**ADDENDUM  
NO. 3**

**September 30, 2025**

**VALE FACILITY ADDITION/RENOVATIONS AND  
MAINTENANCE/IT FACILITY PROJECTS**

**Addendum Three (AD.03)** to the drawings and specifications prepared by Gibraltar Design for **Valparaiso Vale Facility Addition/Renovations and Maintenance/It Facility and Related Work** for Valparaiso Community Schools, Valparaiso, Indiana.

© GIBRALTAR DESIGN SHEET  
**C AD103**

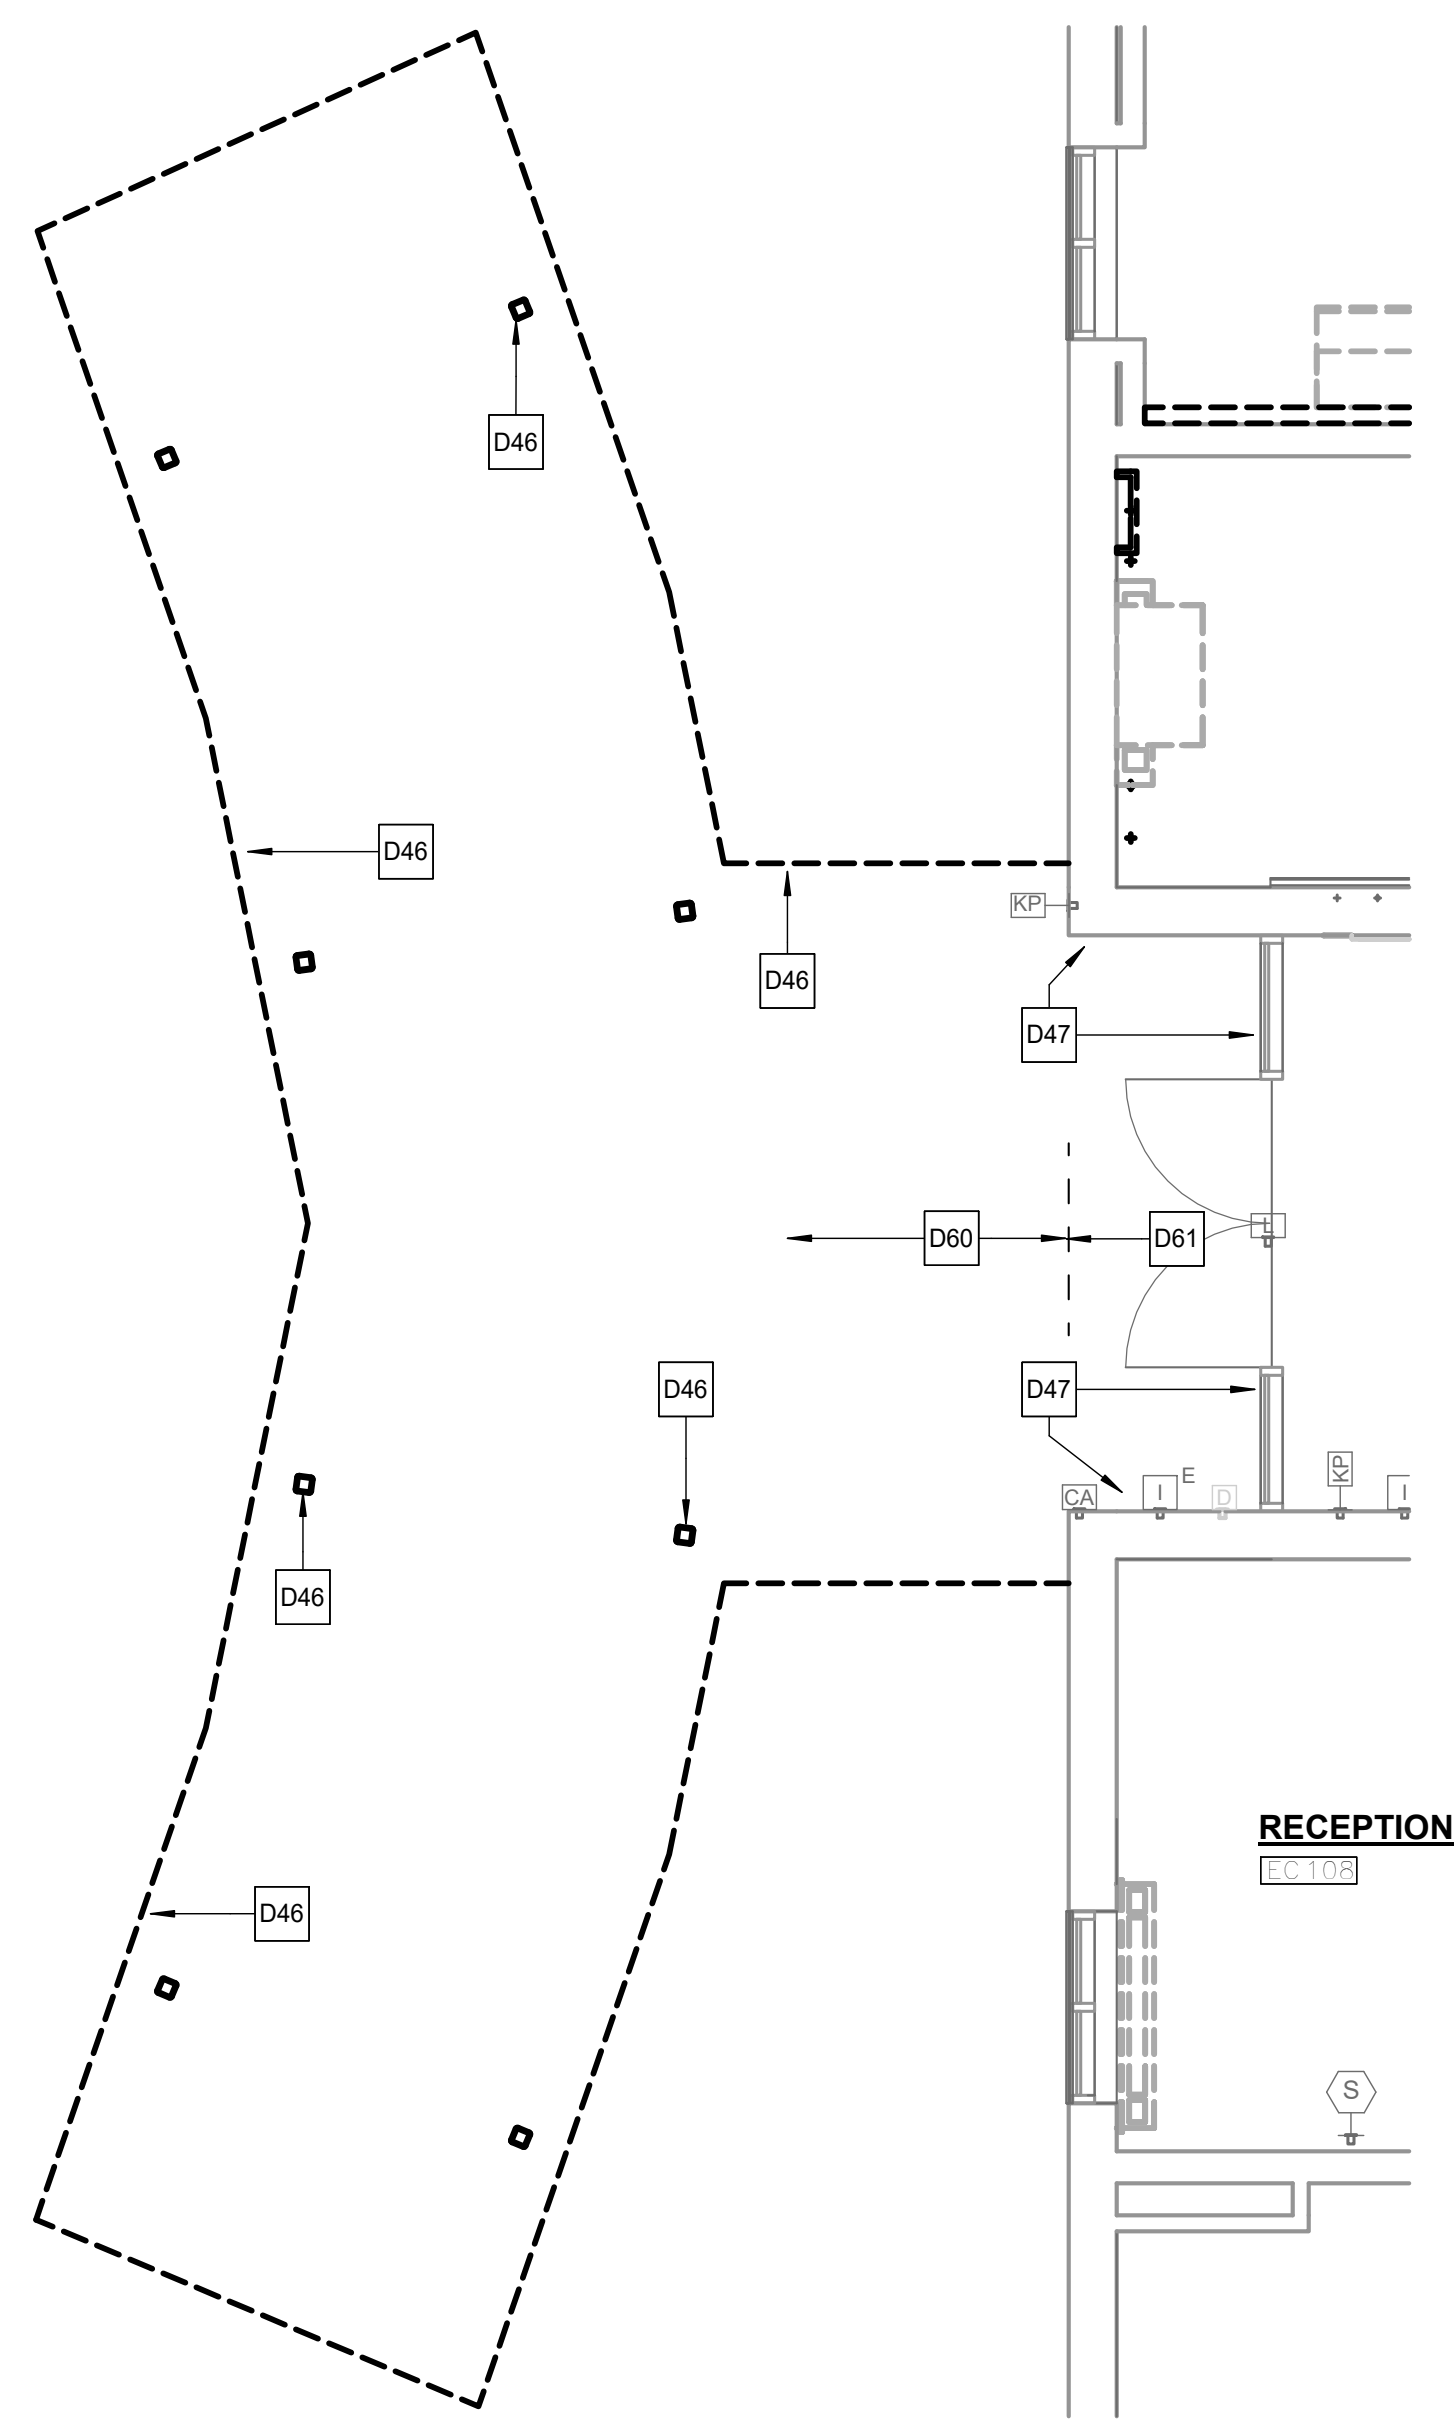
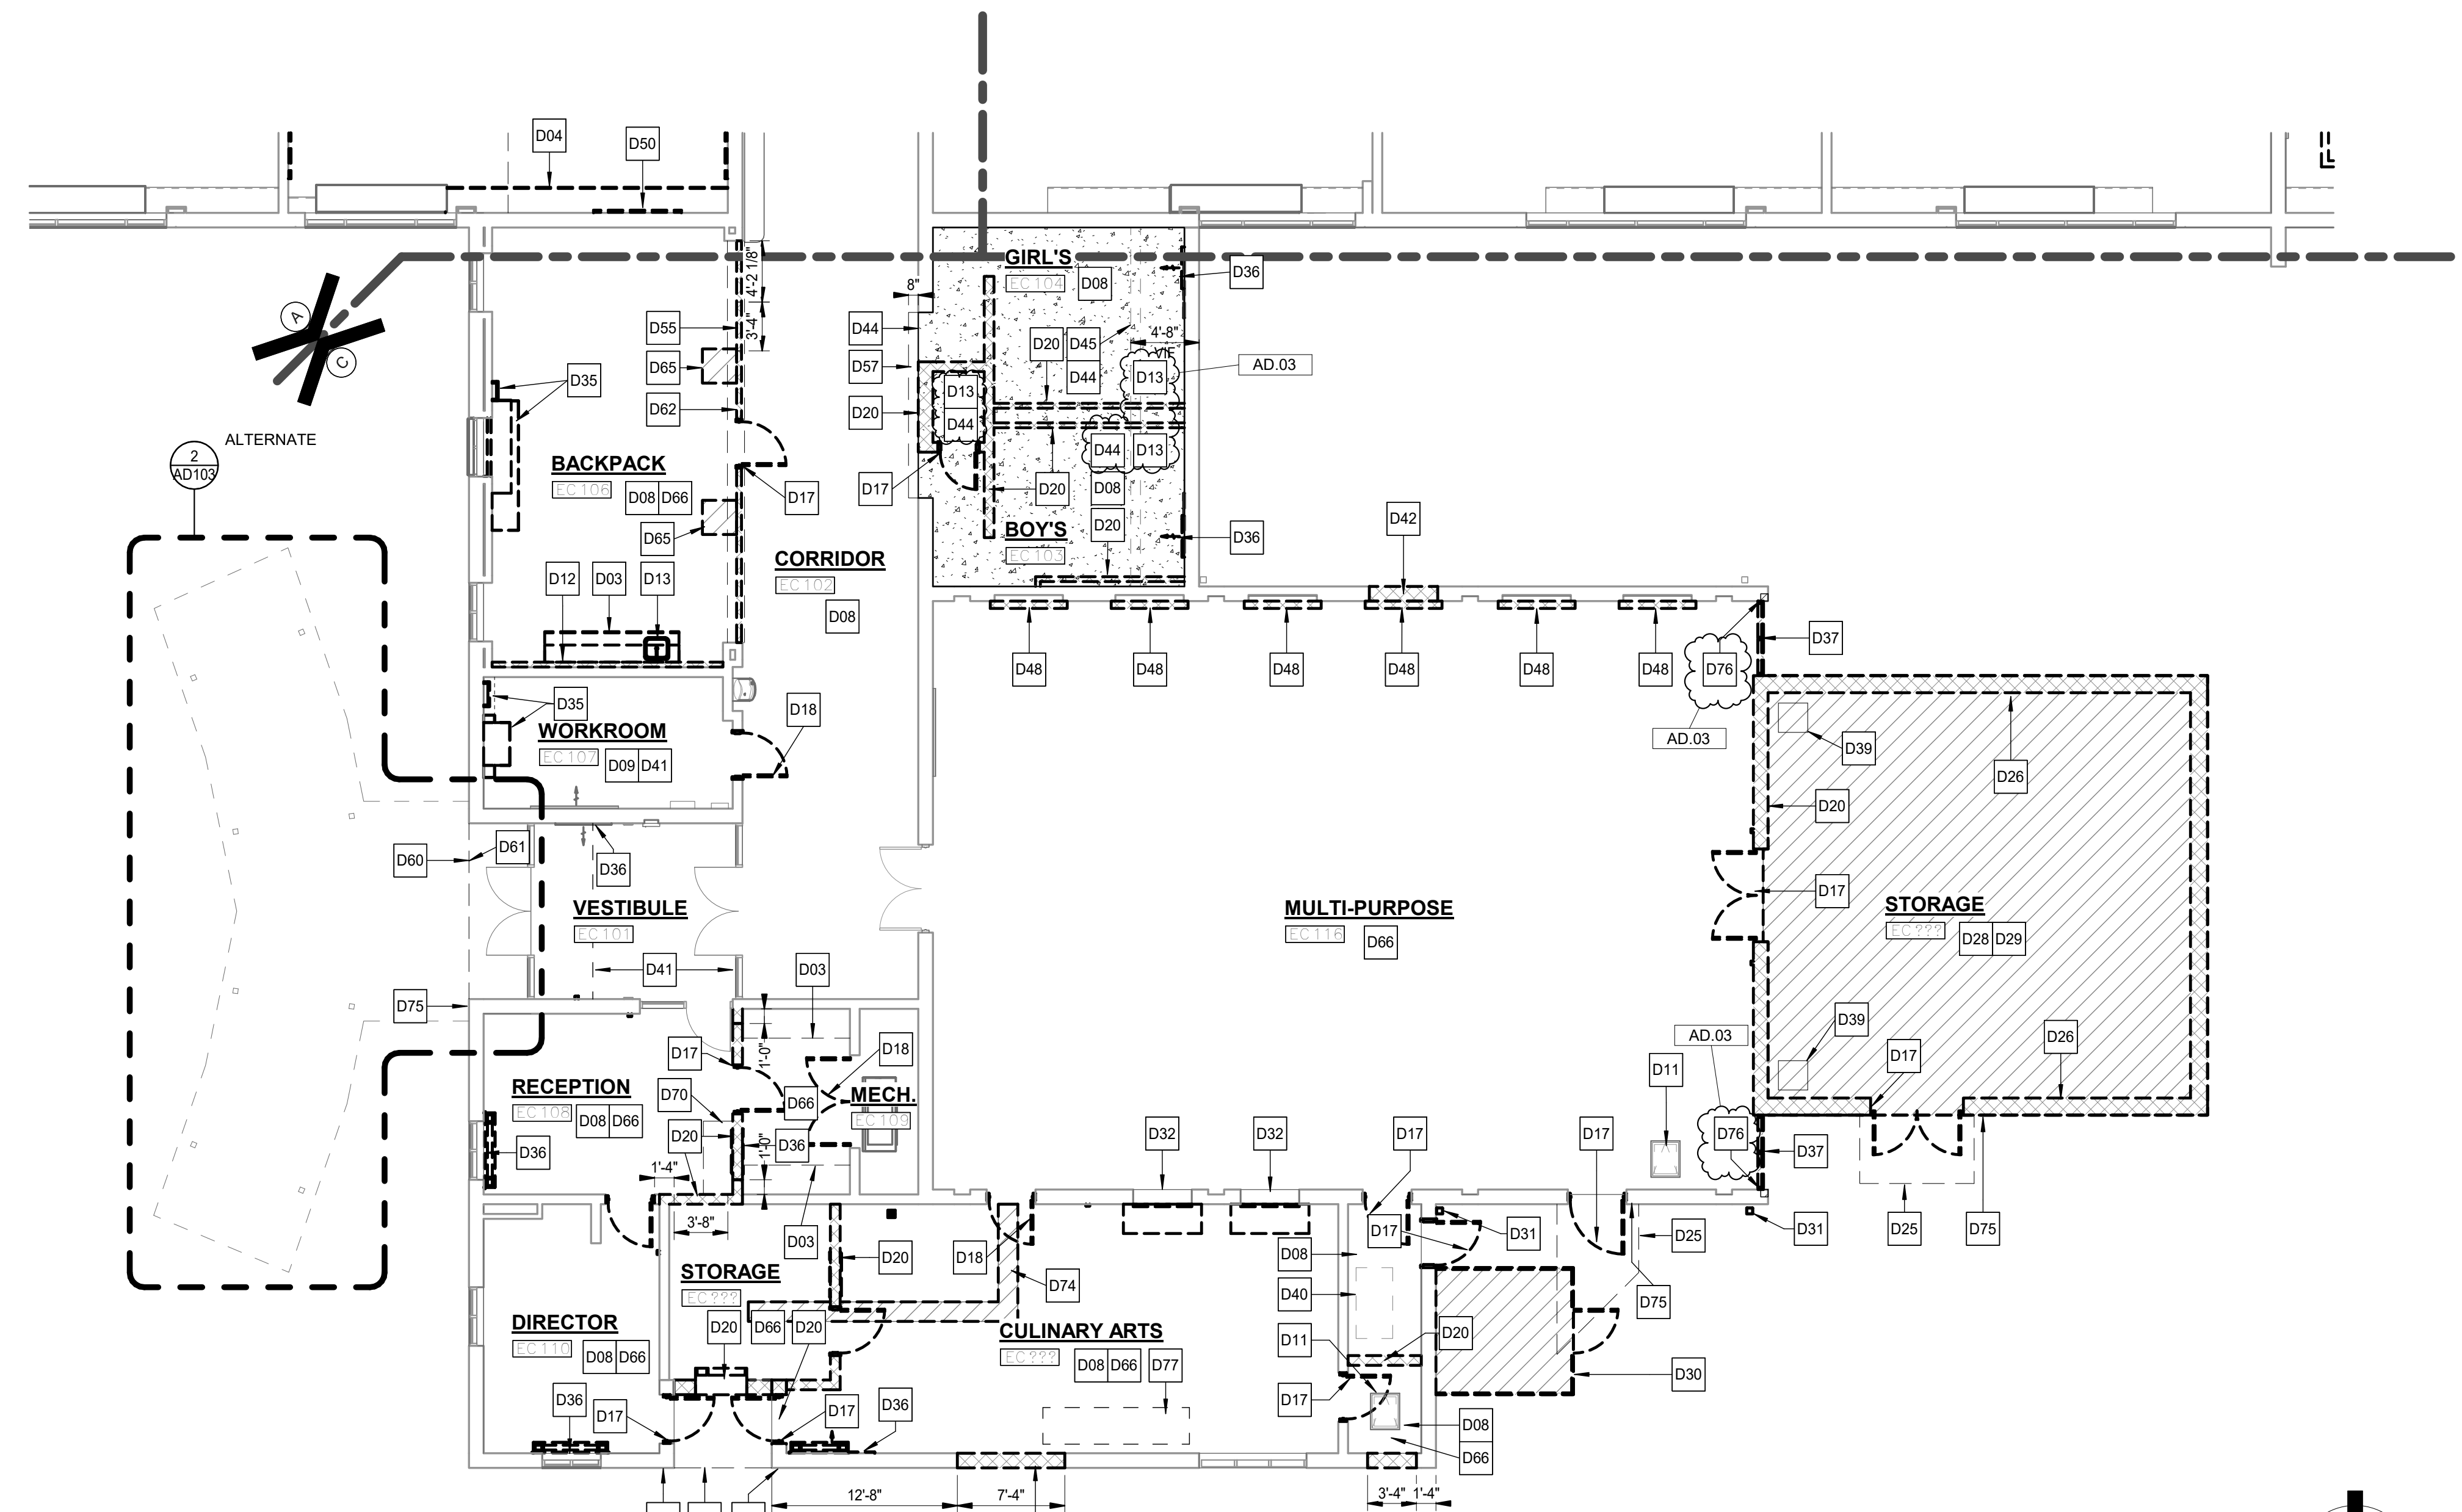
- A. Refer to revised, full-size drawing, included in this Addendum, for revisions.
  1. Keynotes added to Boys EC103 and Girls EC104 and adjacent janitor room.
  2. Keynote D76 added to Multipurpose EC-116.
  3. Keynote D77 added to Culinary Arts Room "???"
